General Service Bulletin

Evaporator Condensate Dripping on Filters and Infiltrating Return Section Voyager™ Light Commercial T/YHD150-300 Product Code: 0463, 0467

RT-SVB130A-EN (03 March 2016)

Figure 1. Apply foam gasket to the access side

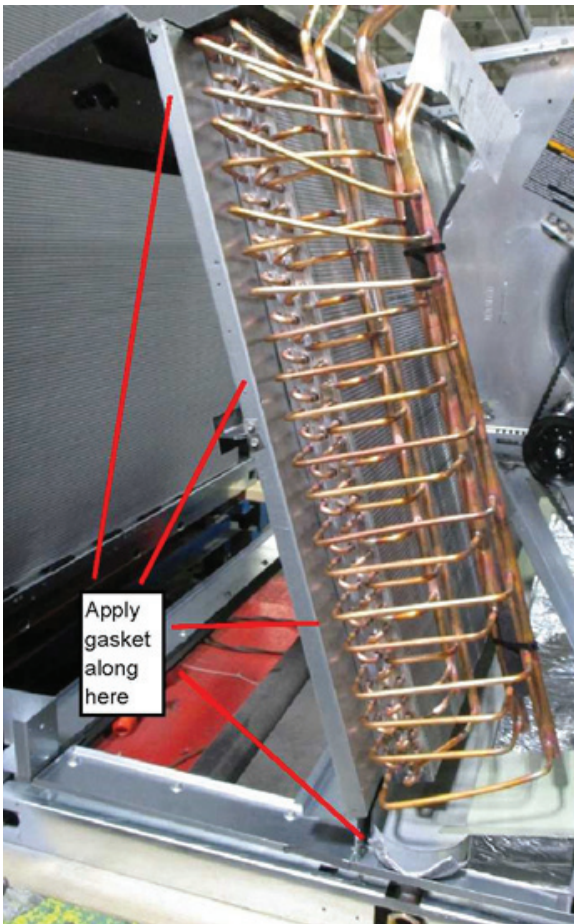
Units that experience air filters getting wet may be missing a gasket along one or both sides of the evaporator coil. This missing gasket allows air to bypass the evaporator coil on either side which prevents the evaporator coil from retaining condensate in the coil as it travels down the coil to the drain pan.

Units experiencing this issue will require the installation of 2 strips of gasket material, one on each side of the evaporator. Some units may only need gasket on one side.

1. Apply foam gasket to the access side if missing. See [Figure 1](#).

Figure 3. Close-up of a correctly aligned drain pan under the evaporator coil

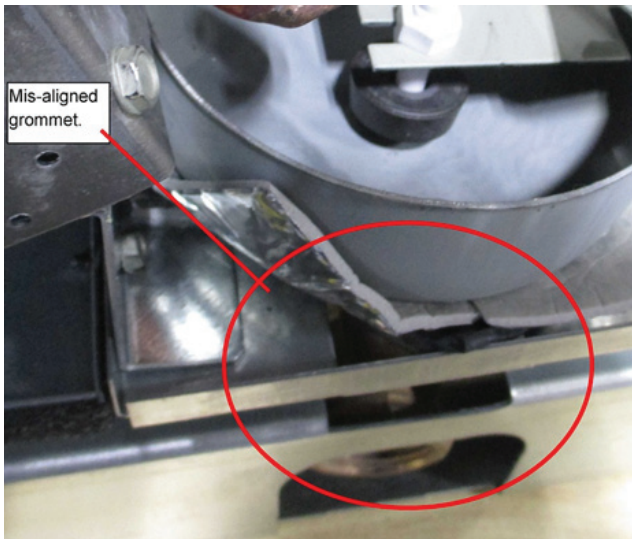
Additionally the drain pan may be incorrectly installed allowing the condensate to drain into the return section of the unit instead of the drain pan itself.

3. Units with mis-aligned condensate drain pans may have an incorrectly installed rubber grommet. If this grommet is turned in the wrong direction it will not allow the drain pan to align properly. Adjust this grommet as needed. No new parts are necessary for this re-alignment. See [Figure 3](#) and [Figure 4](#).
